Access Compliance Report Public Rights-of-Way (Curb Ramps)

Main Street: SKLAR_ST Cross Street: RANUNCULUS_ST Location: E

ADA ID: RPAT211029151334 Ramp Type: Type 1 - Perpendicular Diagonal Initial Pass/Fail: Pass Overall Compliance: No Severity Score: 25

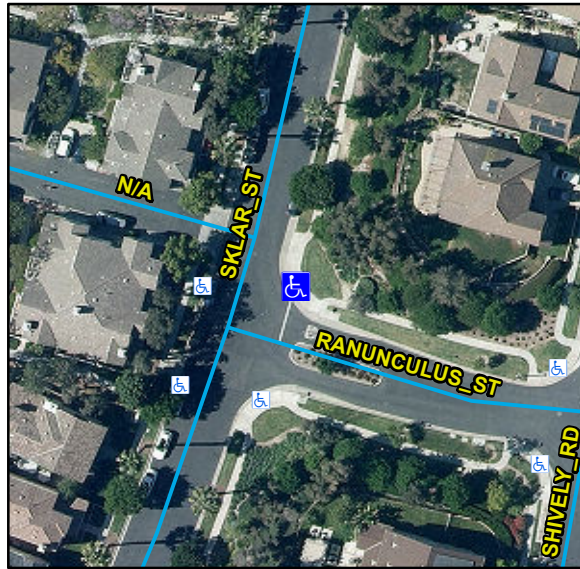
R304.2.2, R204.3, R304.2.1, R304.2.2-Perp, R304.3.2-Para, R304.5.3, R305, R304.5.4, STD 1115

N/A	Ramp Inside Crosswalk 1	N/A	Yes	Ramp Inside Crosswalk 2	N/A
	Crossing 1 Slope (%)	0.1		Crossing 2 Slope (%)	1.4
	Crossing 1 Cross Slope (%)	2		Crossing 2 Cross Slope (%)	2
Yes	Gutter Ponding	No	No	Curb Slope	7.4
Yes	Gutter Lip Height (in)	0		Road Run Slope (%)	0.7
No	Gutter Run Slope (%)	8.5		Road Cross Slope (%)	3.9
Yes	Gutter Cross Slope (%)	1.3			
Yes	Overall Surface Condition: Acceptable		No	Perp Joint Present	No
	Cross Gutter Present?	No		Spandrel Present?	No
	Replace Cross Gutter?	N/A		Replace Spandrel?	N/A

Remove & Replace Curb Ramp With Two New Directional Ramps or Equivalent. Remove & Replace Gutter.
